Title: 8600/TranStar Hood Latches Do Not Fit Correctly

Applies To: All 8600/TranStar models that have had or will have the hood latches and/or the fender extensions replaced.

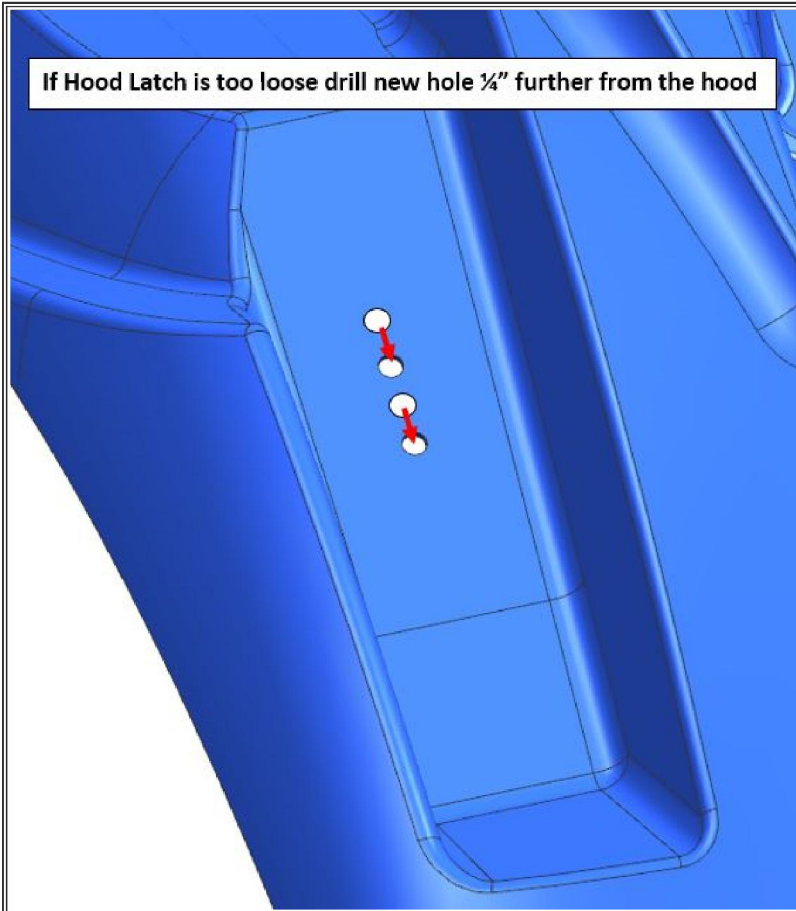
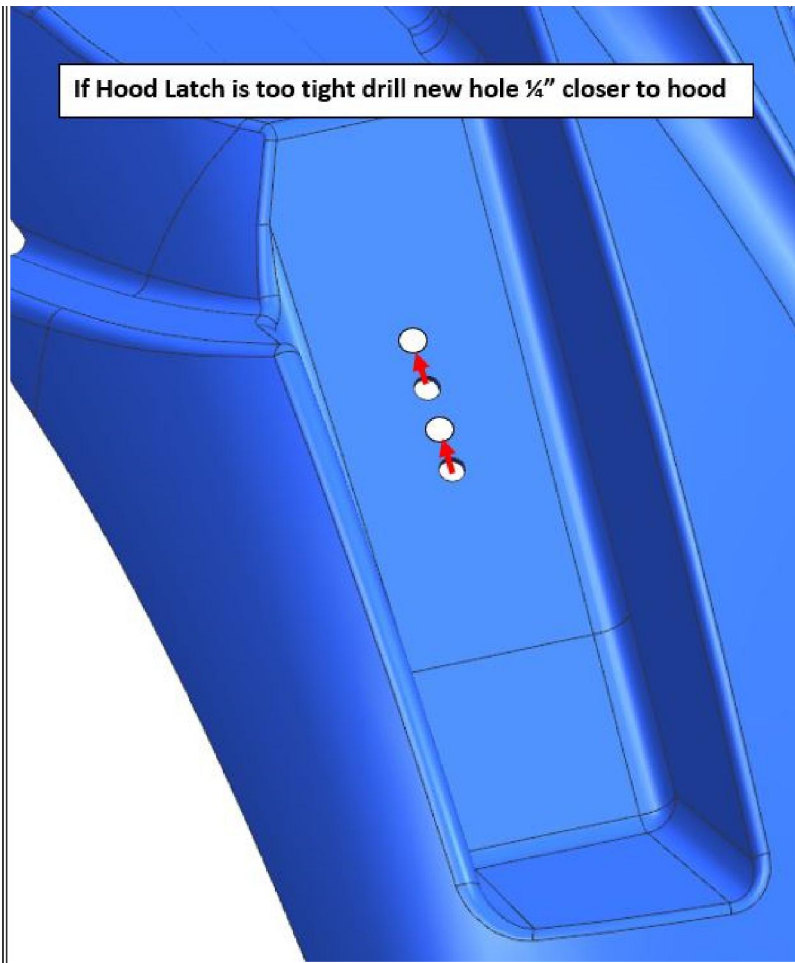
Due to a design change between the hood latch and fender extension, the latch may be too loose OR too tight, depending on the age/revision level of the latch and/or fender extension.

Condition 1: If the latch is too tight, mark & drill new holes up ¼" closer to the hood.

If there is a mismatch between the age/revision levels of the latch and fender extension and the latch is either too loose or too tight, new latch mounting holes must be drilled in the fender extension to change the position of the latch.

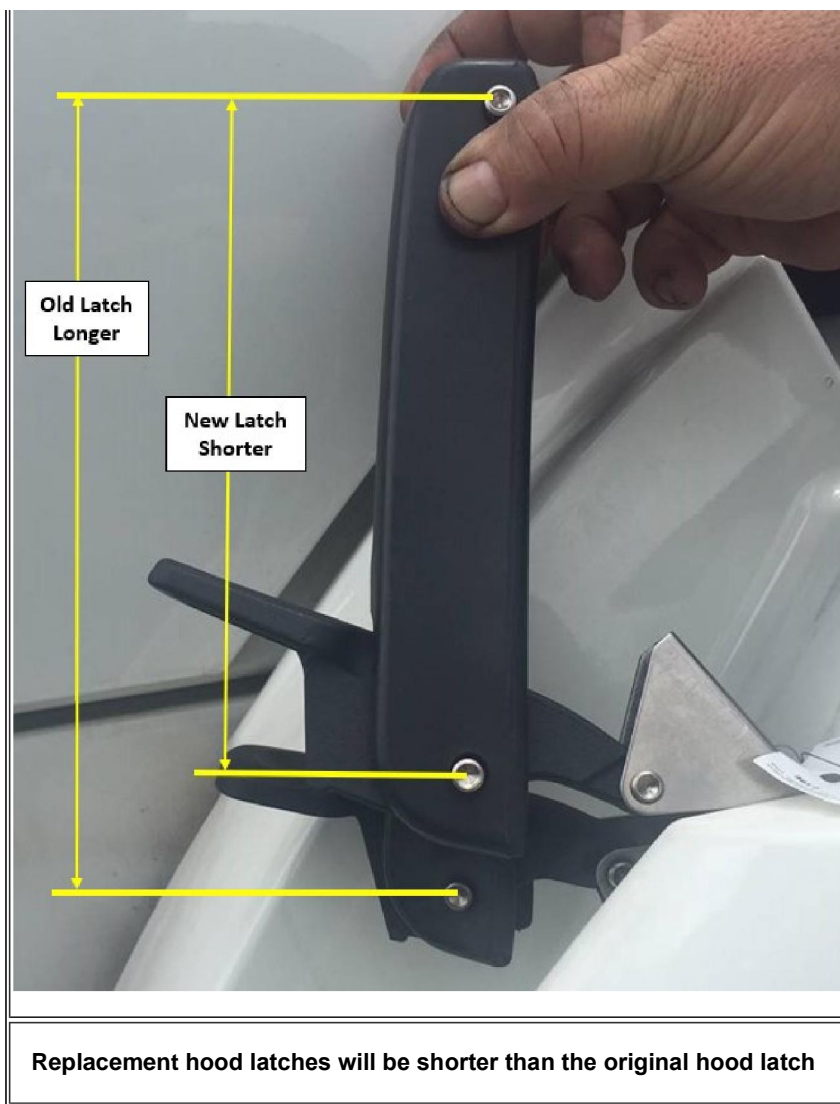
Condition 2: If the latch is too loose, mark & drill new holes down ¼" further away from the hood.
